Recommendation Meeting
221 W Republican St.
Project Number: 3007374
March 5th, 2008

Comments from Early Design Guidance Meeting dated October 3, 2007

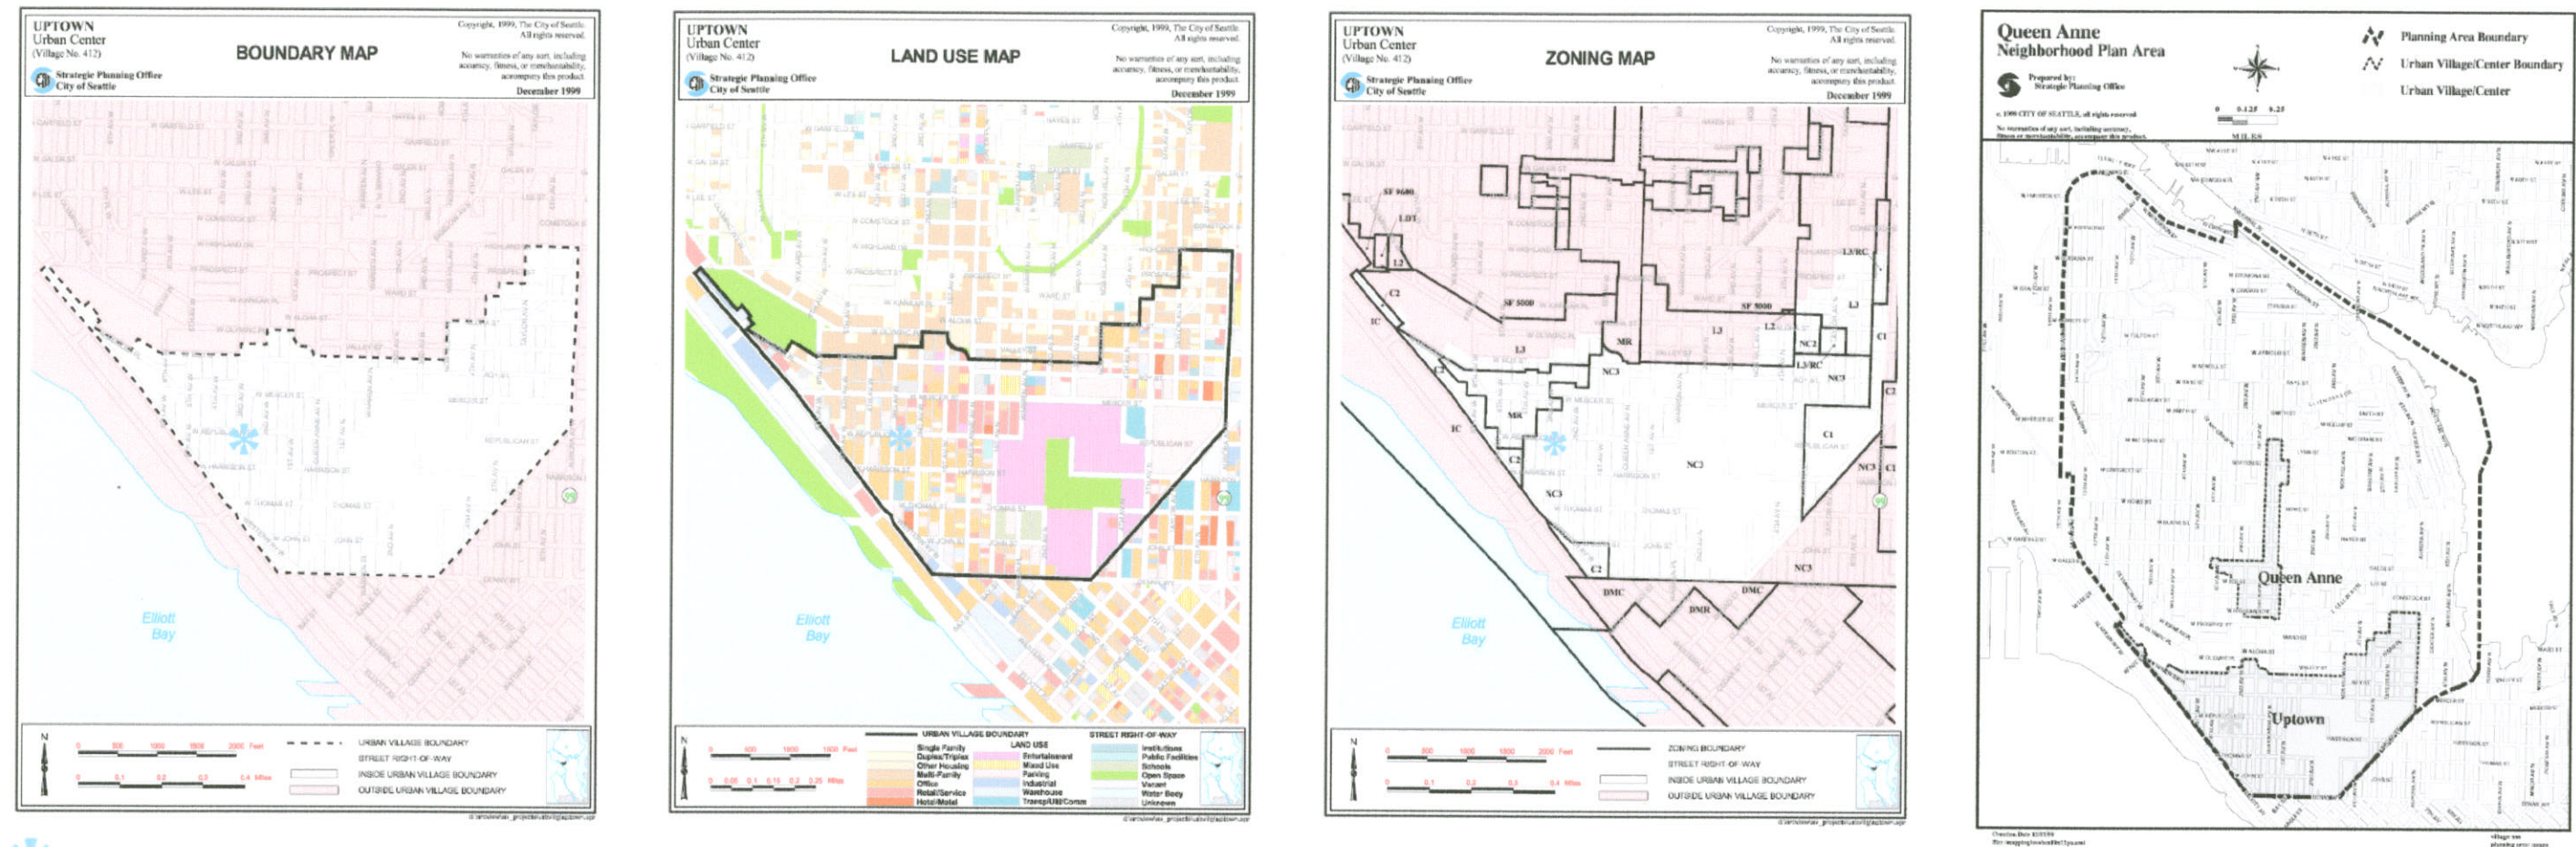
The board thought more consideration should be given to the alley elevation.

The recessed entries for the live/work entries were appreciated. The board questioned placing the main entry and lobby at the NW corner of the building.

The necessity for a departure concerning the transparency along 3rd Ave was questioned.

Along the alley a few design elements have been added. The brick has been extended further (approximately half the elevation) along the ally. A bay window has been added to levels 2,3,4 along the ally. A large access door from the alley has been added to the garbage area. Between the meetings it was learned that a 2' alley dedication was needed at the alley. Because of this no plantings are possible between the building and the alley.

The live/work entries are all recessed and at grade with the sidewalk along W Republican. The main residential entry was moved away from the corner and replaced with an entry loggia along 3rd Ave which is a semi-public space that creates a transition between the street and the entry

Due to the change in grade (approx. 8') along 3rd Ave West (the west property line) the façade transparency is limited within the required ground-related heights. The slab height of the main commercial level is located at the elevation of the northwest corner of the site. Since the commercial slab is flat and the space below this level is devoted to parking, little transparency is possible along this façade within 2 to 8 feet from the sidewalk elevation. Landscaping will be used to buffer the blank wall along this façade. We are still requesting a departure for this requirement.
